**CITY OF WILSONVILLE
SECOND AMENDMENT TO CONSTRUCTION CONTRACT**

5th Street/Kinsman Road Extension

**Exhibit A - Change Order #02
Pay Item Adjustment**

Exhibit B – Change Order #02 Pay Item Detailed Description

Pay Item 2003: Bridge Wing Wall Fence

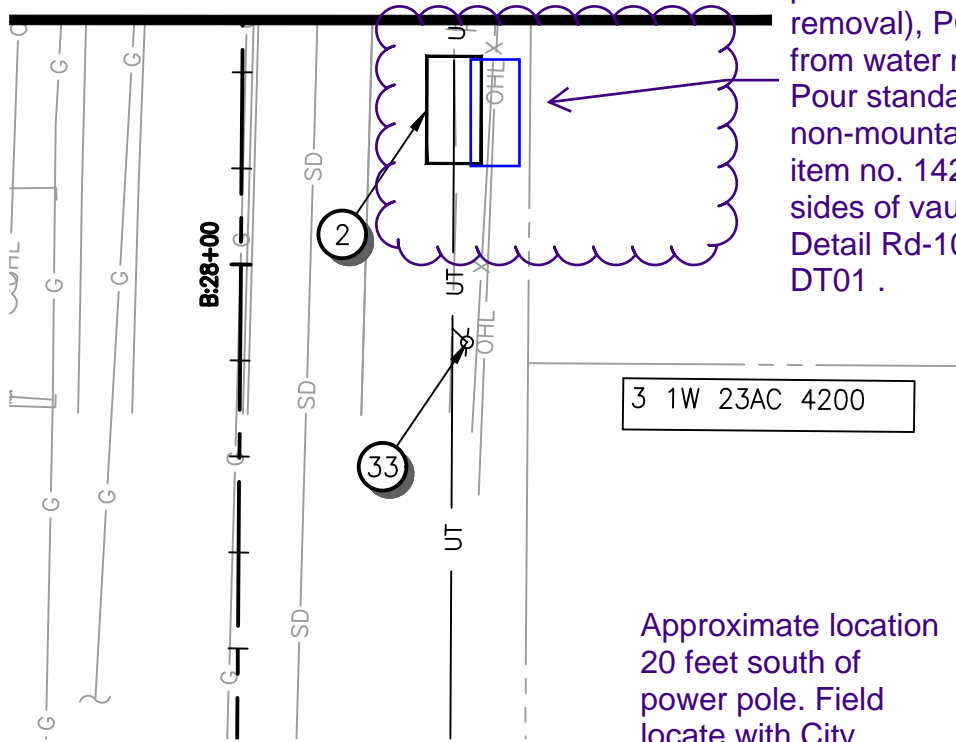
Contractor raised a safety concern with the design engineer regarding a potential fall hazard where the sidewalk is adjacent to the bridge wing wall. There is an elevation difference of up to 4 feet between the top of the bridge wing wall and the adjacent Coffee Lake Creek with no barrier provided between the sidewalk and bridge wing wall. The City and design engineer agreed with the Contractor's safety concern and proposes installation of a 4-foot high, black, vinyl coated, chain link fence for each wing wall on both the 5th Street Bridge and Kinsman Road Bridge as documented in RFI 080 (p. 29-32 of Exhibit C).

Contractor provided timely notification to the City that the added bridge wing wall fence results in added costs as documented by Change Order Request #021 (p. 33-35 – Exhibit C) and the City has determined that the work is an acceptable reimbursable project expense.

The Bridge Wing Wall Fence pay item shall include all costs for materials, equipment, and labor to construct the fencing as directed in RFI 080 (p. 29-32 of Exhibit C) and Section 01050 of the 2018 Oregon Standard Specifications for Construction. This pay item will not be measured in the field and will be paid on a lump sum basis at the Contract price.

Modify Water Quality Facility for PGE Vault 68

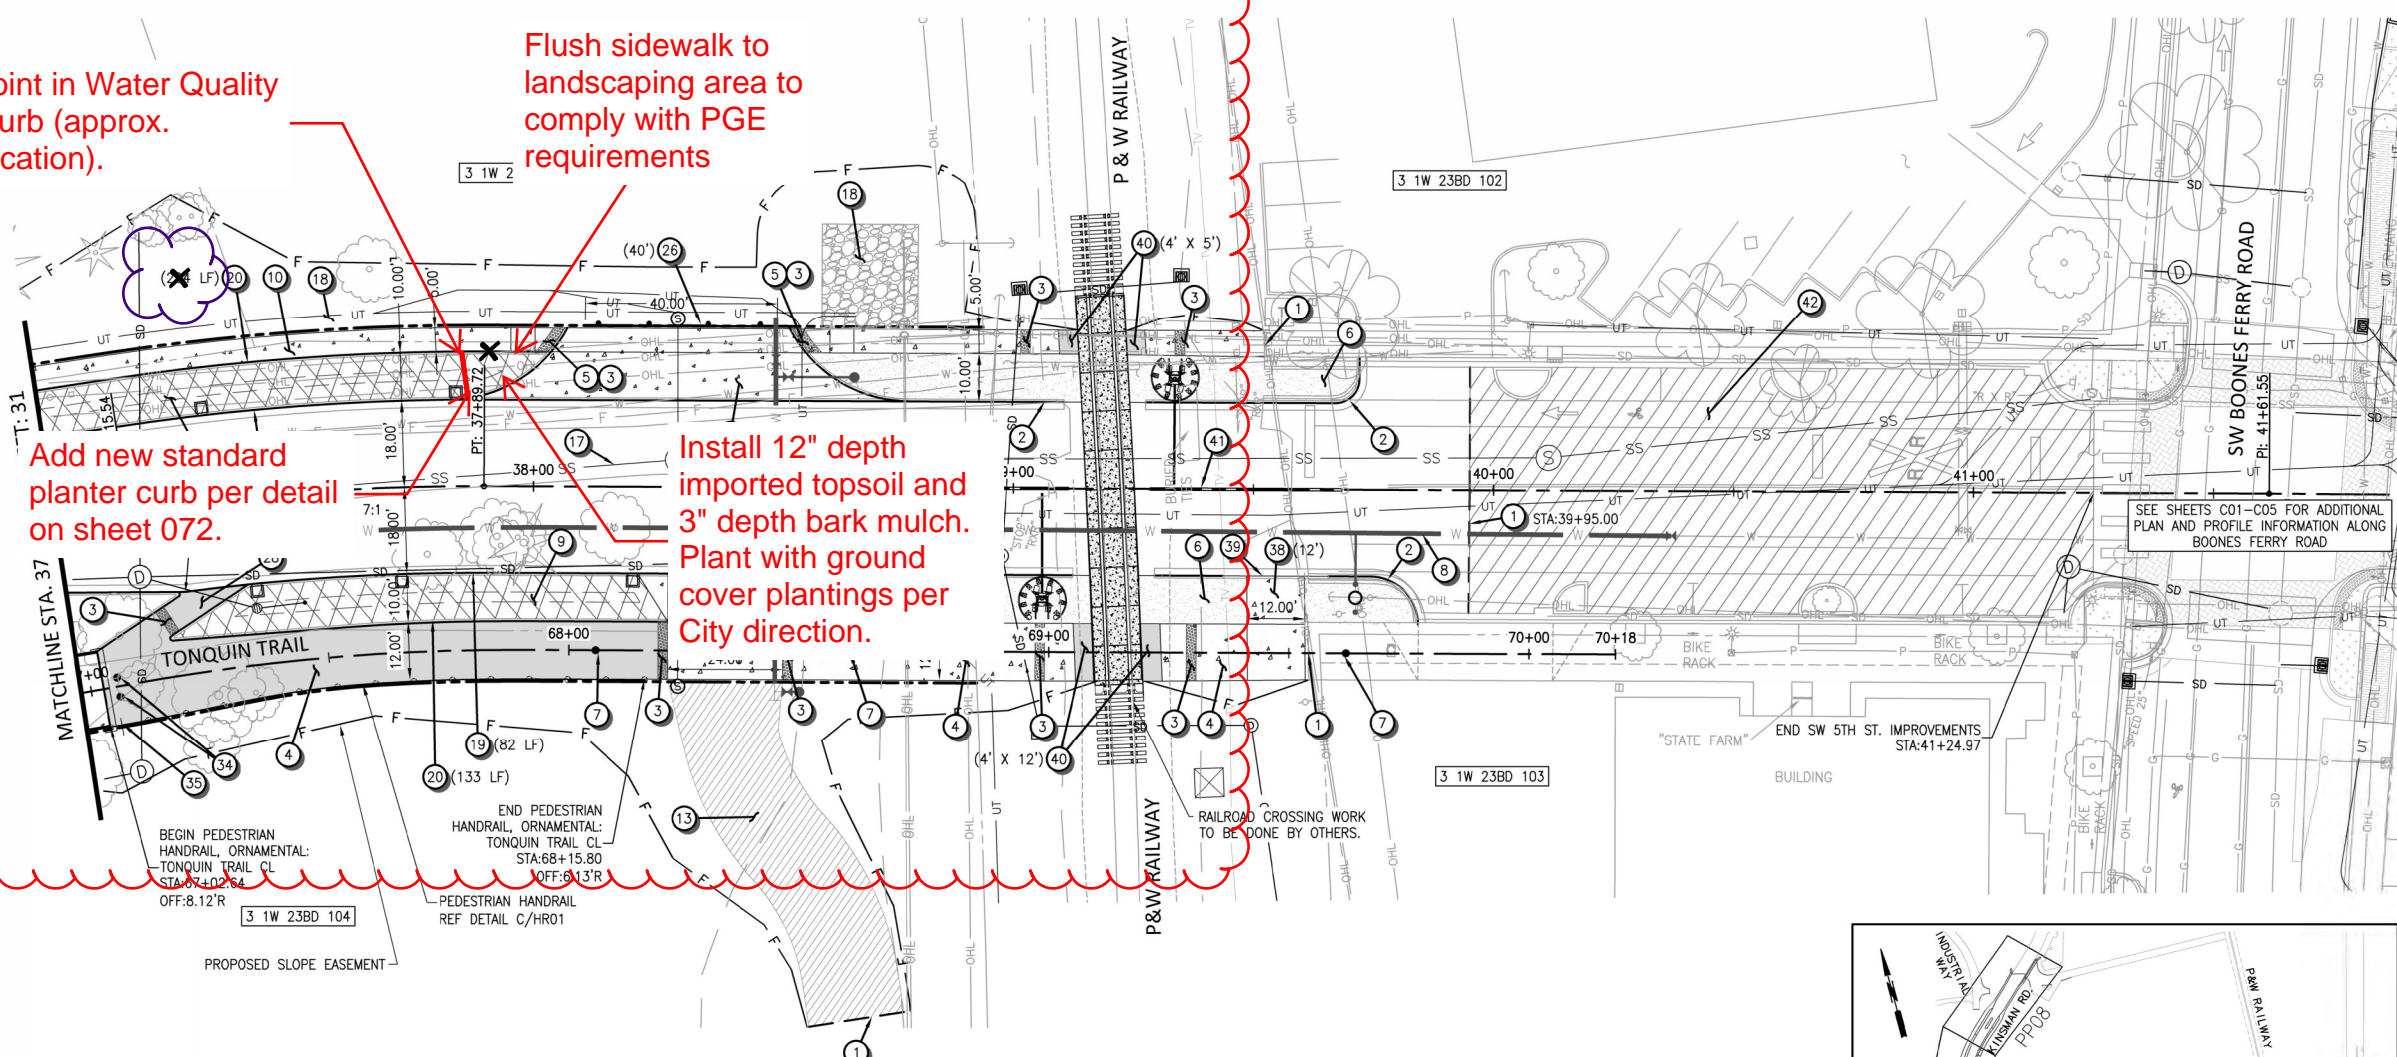
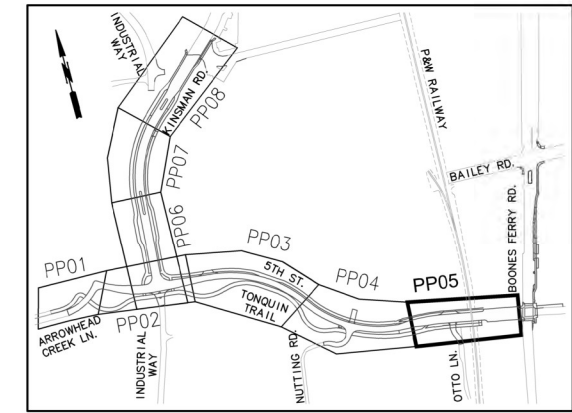
Modify Water Quality Facility for PGE Vault 68 – During construction of the underground electrical infrastructure, PGE requested that the water quality facility located south of PGE Vault 68 be replaced with a standard landscape strip to provide PGE required 10 feet worker safety clearance. The design engineer reviewed the request and confirmed the design change can be accommodated and is documented per Change Order Request #018 (p. 8-11 – Exhibit C). The design change results in a net decreased estimated quantity of Pay Item 148 – Concrete Water Quality Curb and increased estimated quantity of Pay item 141 – Non-Mountable Median - Concrete Street. It is assumed that the difference between backfill, excavation, soil, plantings and all other work not specifically identified in this Change Order No. 2 for the conversion of the water quality swale and the landscape planter strip is negligible for which no separate or additional measurement or payment will be made.

Prior to modification of the water quality facility for PGE Vault 68 as described above, a 12-foot long section of water quality curb had already been installed to the south of the vault. To accommodate the

conversion of the water quality facility to a standard landscape strip, this section of water quality curb needs to be removed.

Joint in Water Quality Curb (approx. location).

Flush sidewalk to landscaping area to comply with PGE requirements

Add new standard planter curb per detail on sheet 072.

Install 12" depth imported topsoil and 3" depth bark mulch. Plant with ground cover plantings per City direction.

Add Standard Curb to PGE Vault 221

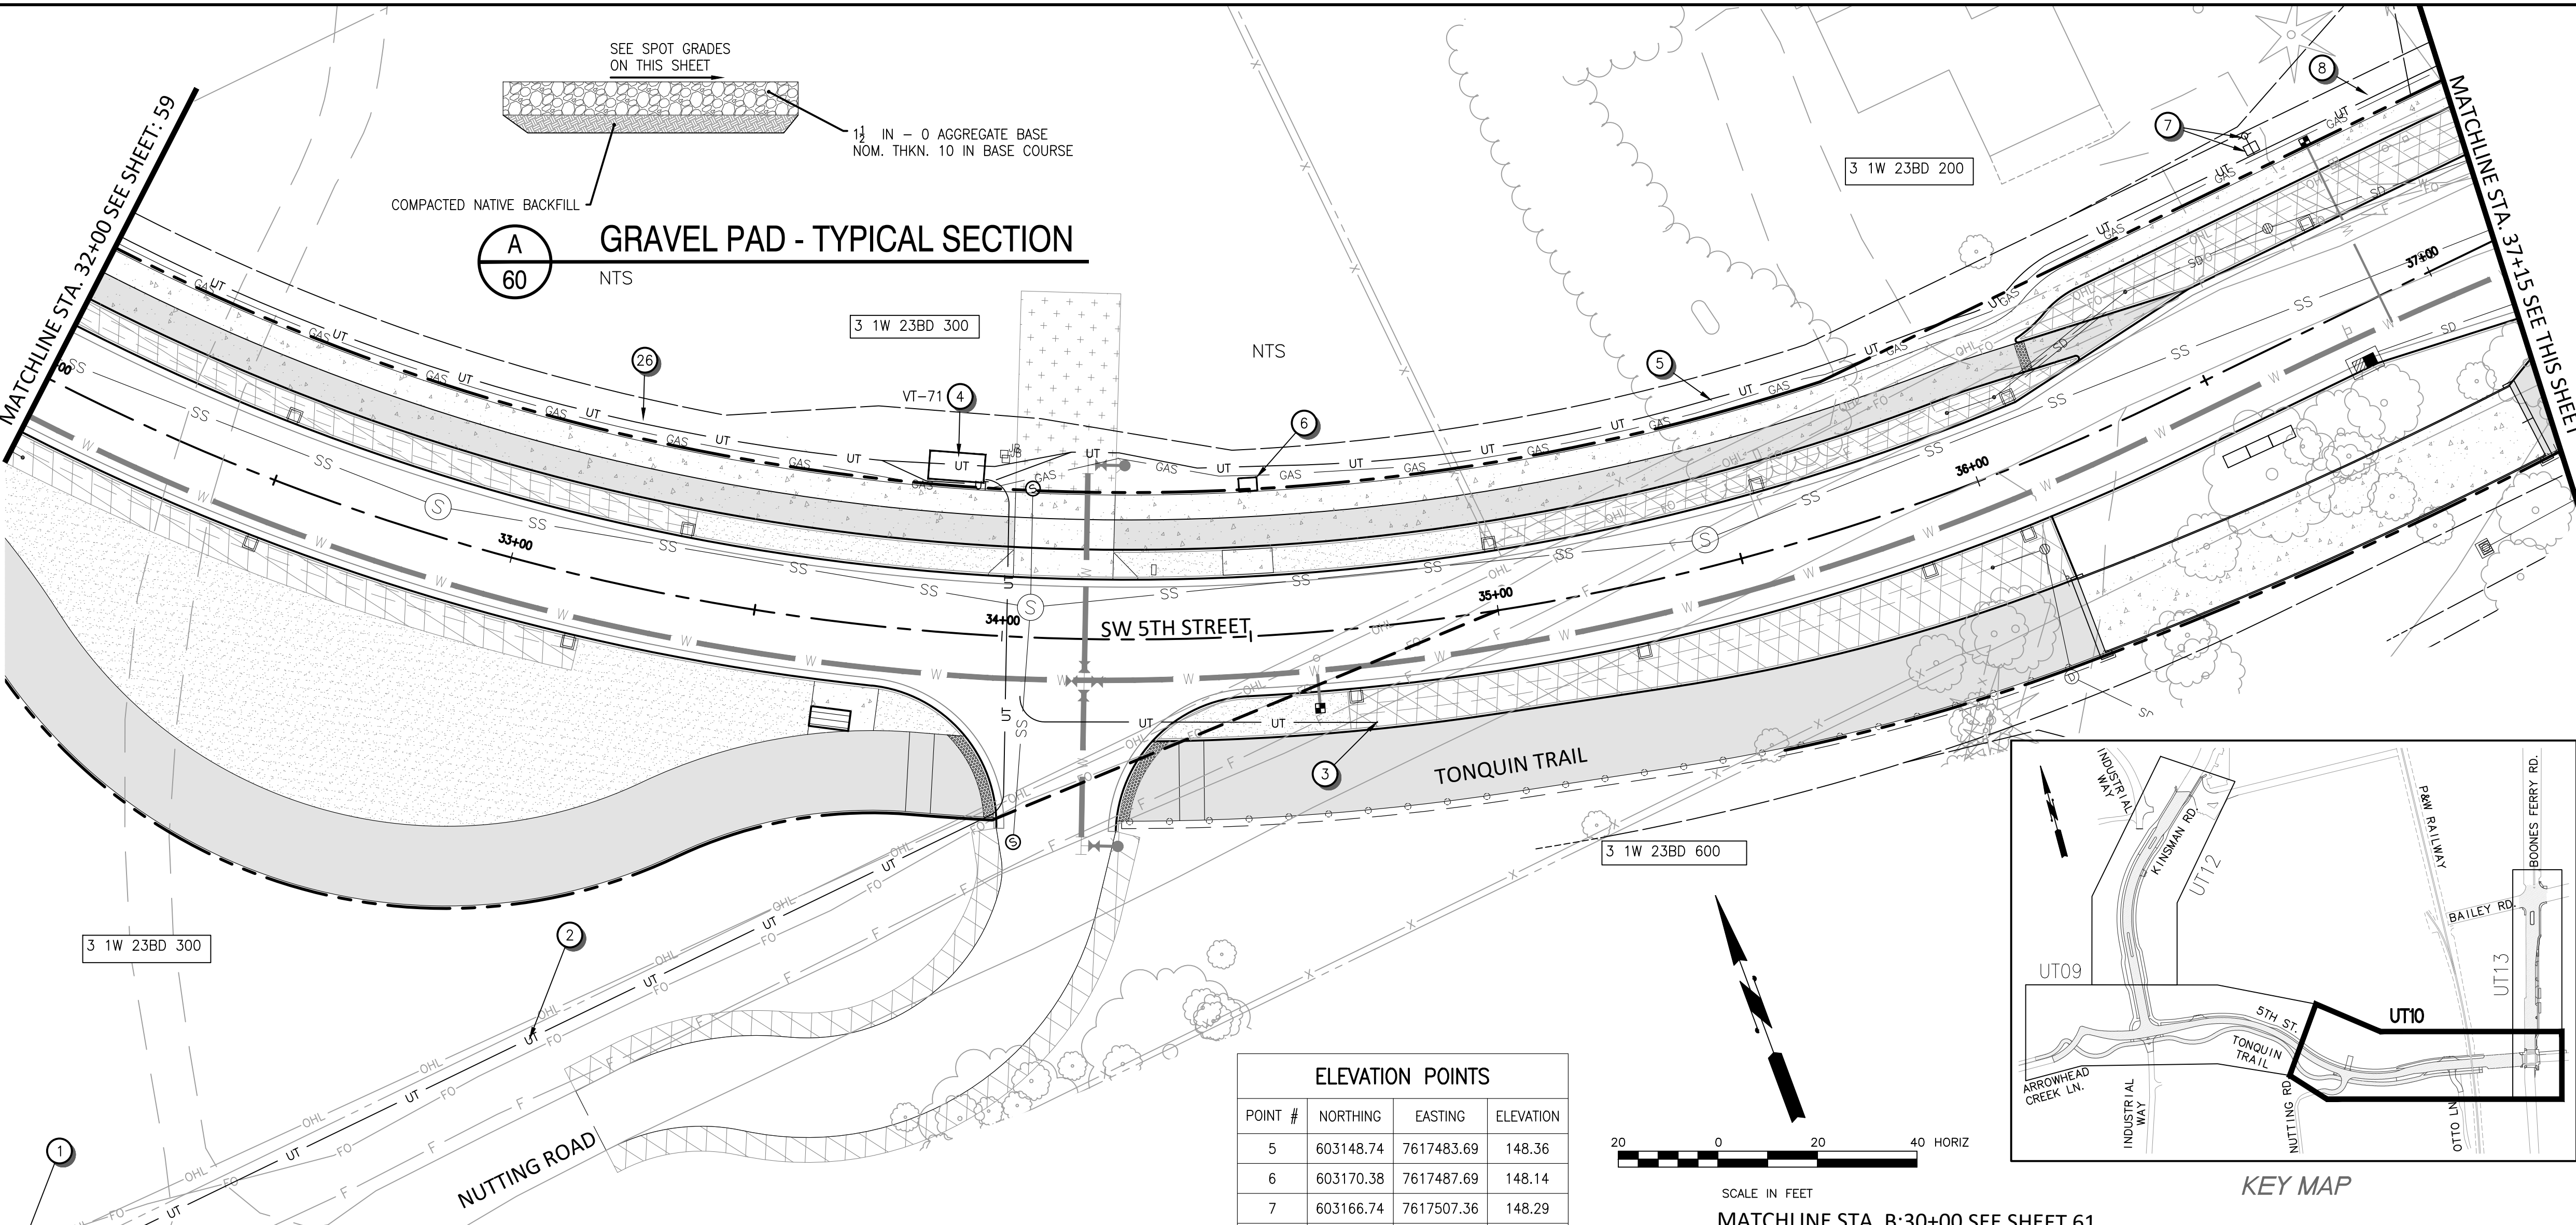
Add Standard Curb to PGE Vault 221 – During construction of the underground electrical infrastructure, PGE requested standard curb be installed along the outside edge of electrical vaults located within parking areas. PGE Vault 221 is located along an unimproved portion of Boones Ferry Road, south of 5th Street within an existing gravel area adjacent to the paved roadway. PGE vault lids are not structurally rated for traffic loading. As a result, PGE has requested standard curb be installed along the south, west, and north edges of PGE Vault 221 to prevent vehicles from driving over or parking on top of the vault lid. The design change is included on page 4 of Exhibit C. This design change results in increased estimated quantity of Pay Item 142 – Non-Mountable Median - Asphalt Streets.

STA. B:28+25 SEE SHEET: 60

Approximate location for vault 221.

Field adjust based on fence post locations (minimal removal), PGE clearances (2' from water main)
Pour standard 6" non-mountable median (bid item no. 142) around front and sides of vault to protect it - See Detail Rd-1065 on Sheet 122, DT01 .

Approximate location 20 feet south of power pole. Field locate with City Inspector and PGE.

**SW 5TH ST TO SW KINSMAN RD EXTENSION
5TH ST - UTILITY TRENCH**

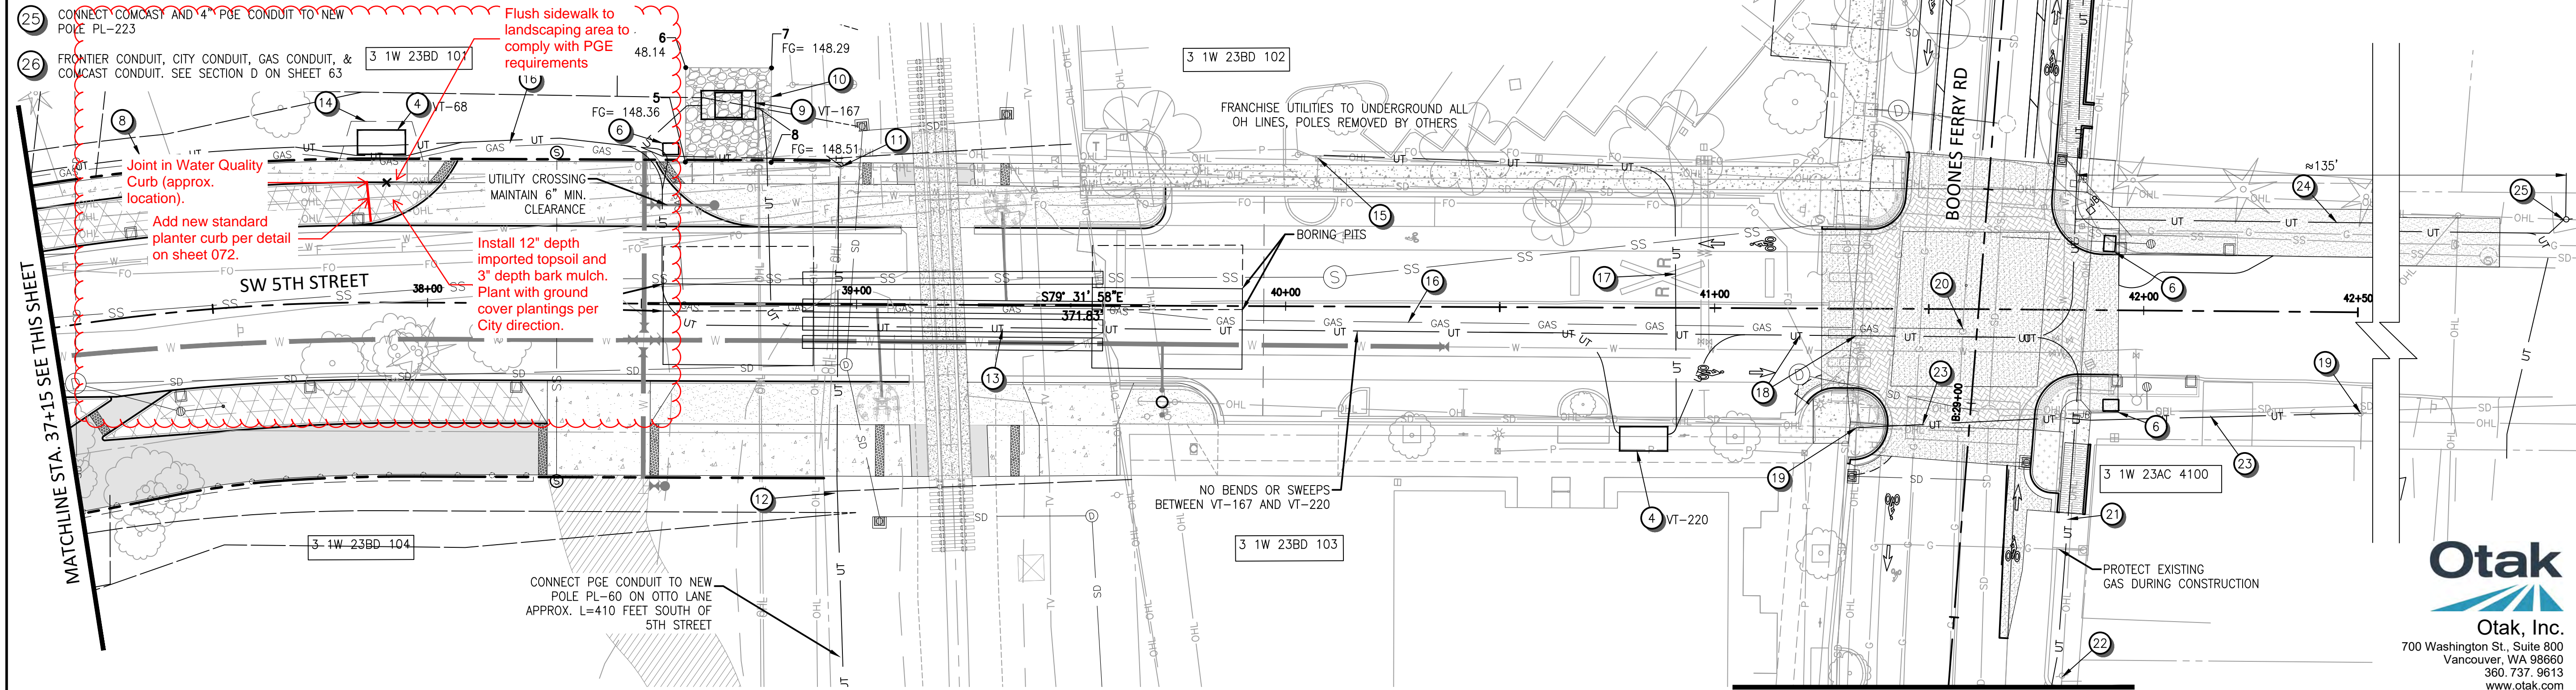
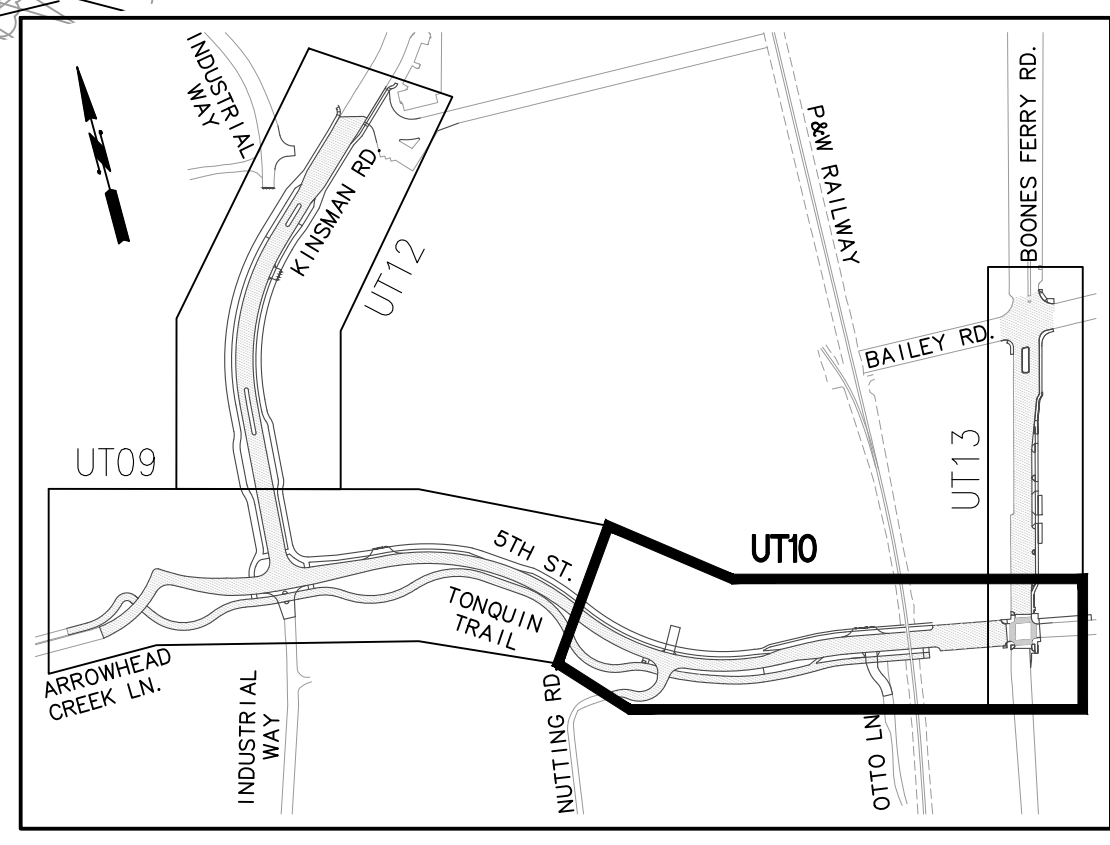
REMOVE 12-FT SECTION OF CURB IN FRONT OF 612 PGE VAULT; POUR BACK STANDARD CURB; REQUIRED PER PGE SPEC FOR ACCESS TO VAULT (SHEET UT10)

11-04-2021	REVISE PGE LAYOUT
------------	-------------------
